**EVALUATION OF WATER BUDGET ANALYSES AND TIER 1 STRESS ASSESSMENTS
BY S.S. PAPADOPULOS & ASSOCIATES INC. DECEMBER 2007**

**Sault Ste. Marie Region Conservation
Authority:**

**Evaluation of Water Budget Analyses
and Tier 1 Stress Assessments**

December 12, 2007

Figure 2.3 Water budget components for Tier 1 Stress Assessment, Central Basin

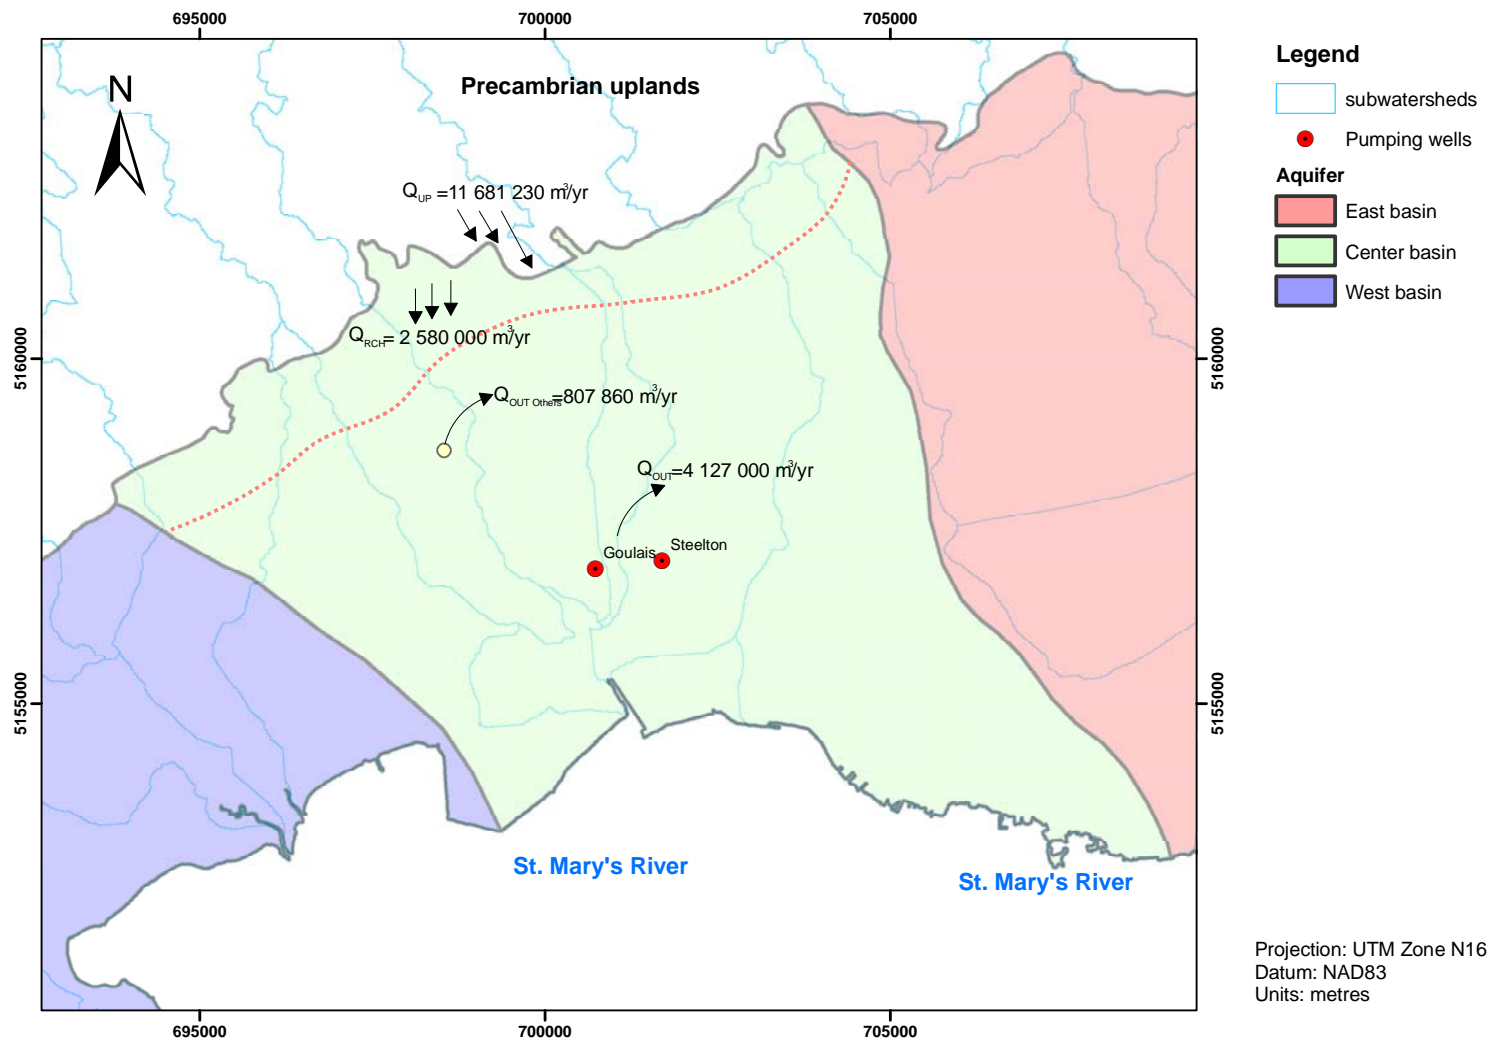
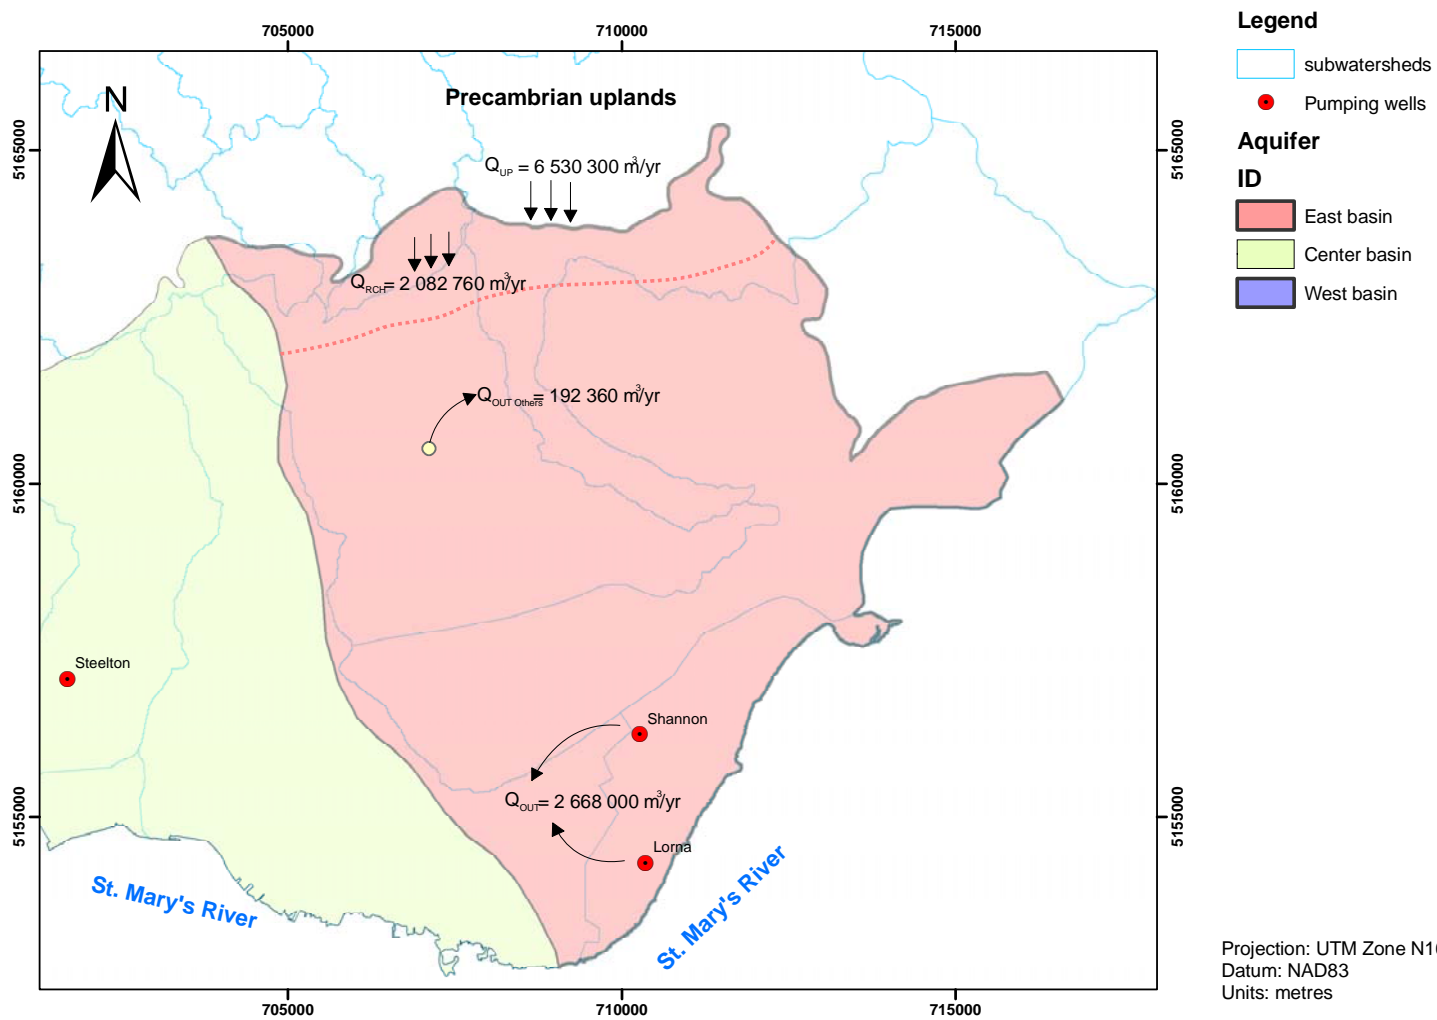
The MacViro and Kresin Engineering conception of a Recharge Zone is also evident in Figure 3.3. The area of the groundwater model over which a recharge rate of 250 mm/yr is applied corresponds to the Recharge Zone shown in Figures 2.3 and 2.4. This rate is somewhat higher than the range of infiltration rates estimated in MacViro and Kresin Engineering, but of a similar order of magnitude.

Figure 3.2 Comparison of calculated and target water levels, original pumping rates

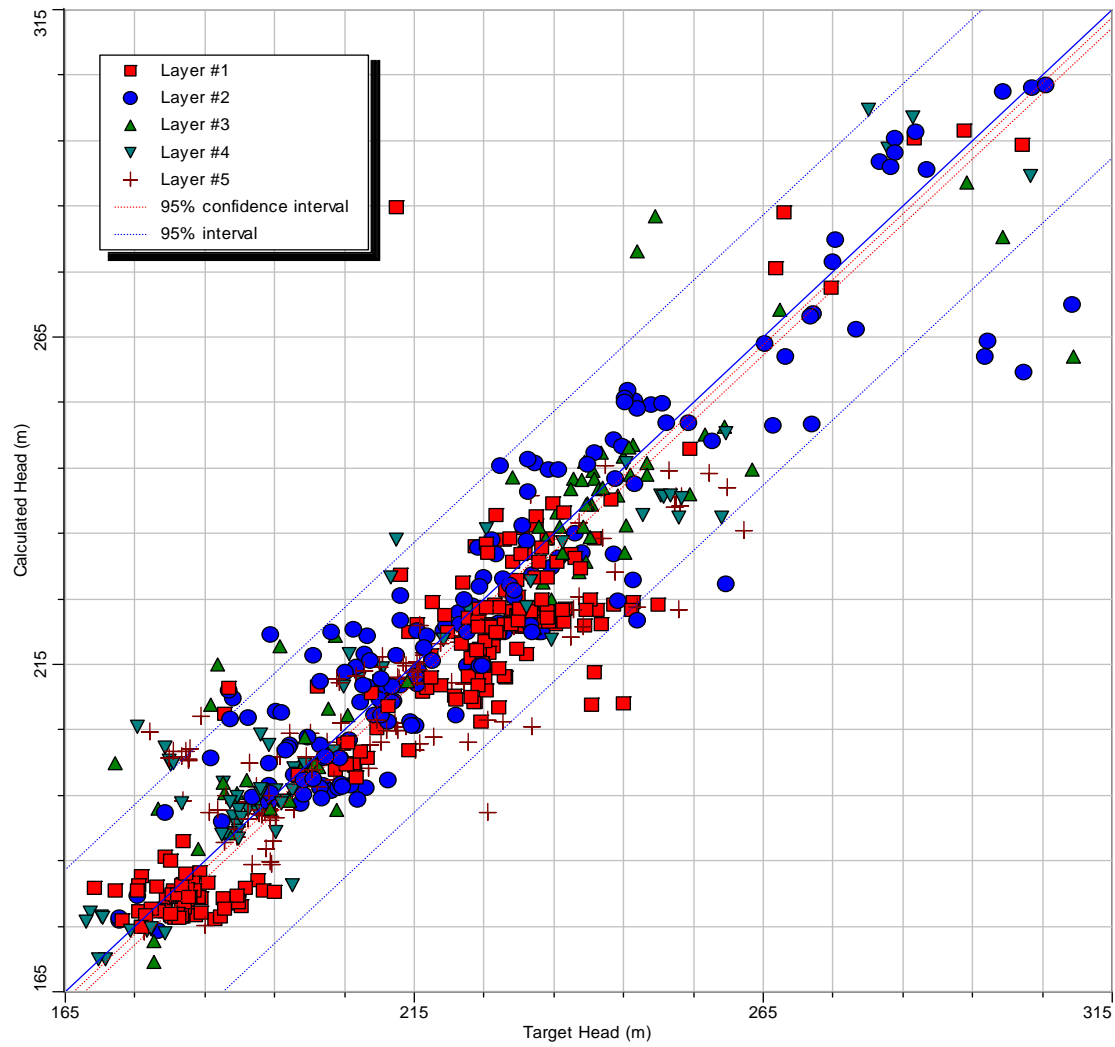
The calculated water levels and targets from the MOE water well records are shown in a scatterplot in Figure 3.2. The results shown in the figure indicate clearly the significant scatter in the MOE targets. The Root-Mean-Square (RMS) error is 10.7 m; in essence, this means that the typical error in water level at a particular location is of the order of ± 10.7 m.

Figure 3.3 Distribution of recharge in the groundwater model

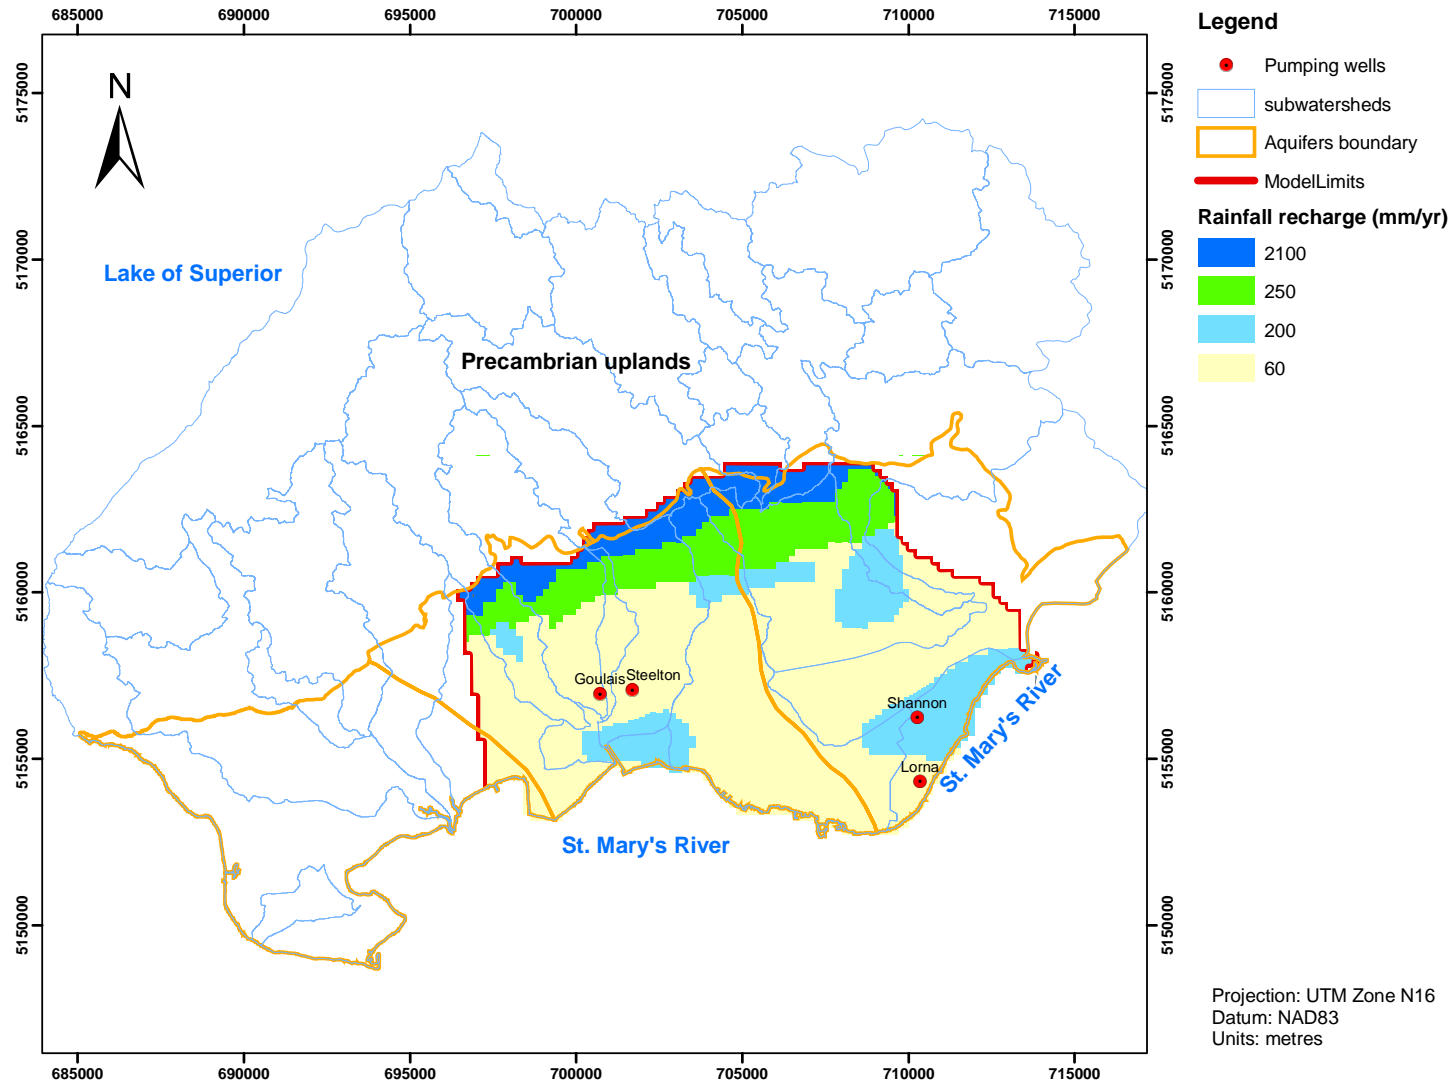
The distribution of recharge is shown in Figure 3.3. The zone of elevated recharge along the boundary is assigned a recharge rate of 2,100 mm/yr. This rate is more than double the annual rainfall, and is clearly intended to account for inflows in excess of the infiltration of precipitation over this area.

Recharge rates of 60 mm/yr and 200 mm/yr are specified over the remaining portions of the model. These rates are relatively high considering that the surficial materials have been described as being clayey. It is also not clear to us how this recharge can be reconciled with the suggestion that there are artesian conditions in the municipal water-supply aquifer. If there are indeed artesian conditions at depth, the recharge applied over the basins could not supply the water-supply aquifer. In the next section, water budgets are developed with the model for the entire basins. If water budgets are developed for the water-supply aquifer itself it may be more appropriate to exclude the lowland recharge from the analyses.
